Ozone Reactivity Measurement of Biogenic Volatile Organic Compound Emissions

Response to Anonymous Referee #1

Figure R1. Response of the fast NO monitor placed after the reactor after injection of NO in the reactor flow for 4 and 6 $l\ min^{-1}$ (in blue and orange, respectively).

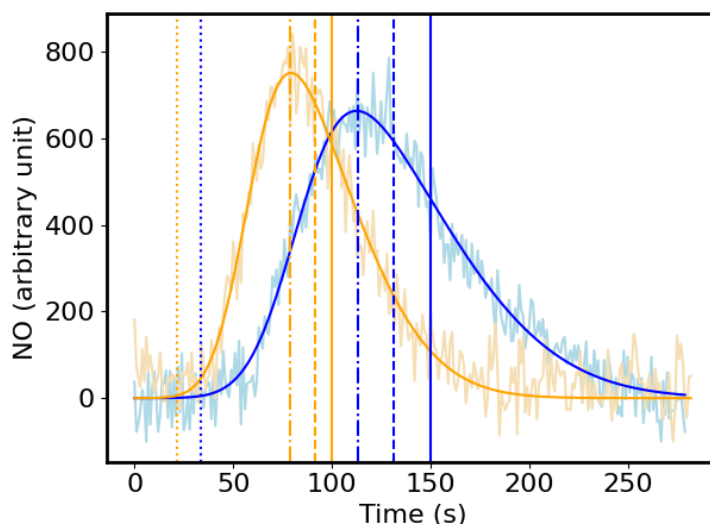
Section 3.4. What is the purpose of changing the plumbing of the reactor? It only shows that in the changed configuration the residence time is a little longer. In any case, why was the residence time determined using a 4 slpm flow, when the actual reactor flow is 4.4 (or 5, see comment above)? In the end, the authors settle on a 120 seconds residence time, which suggests that the theoretical value calculated at 5 slpm was used. But this does not make sense as the experiment described in this section indicate that the theoretical value is ~30 seconds too long compared to the actual value. In addition a residence time of 167 seconds is mentioned on page 22 and a value of 150 seconds is used in Supplement B. The residence time is a key parameter of the system, and therefore it should be clear what it is. The work in this section should be better explained and the reasoning behind the choice of the final value used for all subsequent analysis should be clearly explained.

Changing the flow through the reactor in the reverse direction was done to assess (see line 706) the effect of the dip tube on the flow characteristics of the system. The test confirmed that introducing air through the dip tube results in a narrower distribution for the residence time (lines 716-717), which is advantageous for the purpose of the experiment.

A set of tests were performed to characterize and improve the experiment. Those at times required a different plumbing as the default configuration, which affected the flow through the reactor. However, the experimental determination of the residence time as described in section 3.4 was performed only with one system configuration with flows of 4 and 6 l min⁻¹ through the reactor, with 4 l min⁻¹ used in the default configuration as clarified above. There are various ways to define the residence time, as also discussed by Sommariva et al. (2020), and as depicted in Fig. R1 below. It can be (1) the time when the signal starts to increase, (2) the mode of the distribution, i.e. the most frequent residence time, (3) the mean of the distribution, and (4) the theoretical residence time based on reactor volume and flow rate calculation. In the original manuscript, we used the definitions (2) and (4), leading to the inconsistencies pointed out by the referee. In the revised manuscript, we explain that we use the mean of the residence time distribution (3) for ozone reactivity calculations. These times are 132 s and 79 s for the 4 and 6 l min⁻¹ flows, respectively. This corresponds to fractions of 0.88 and 0.91 of the theoretical residence time. When the flow through the reactor deviates from 4 or 6 l min⁻¹ at which we have experimental data, we applied a factor 0.9 to the theoretical value in order to utilize a residence time that is more in line with the experimentally determined value.
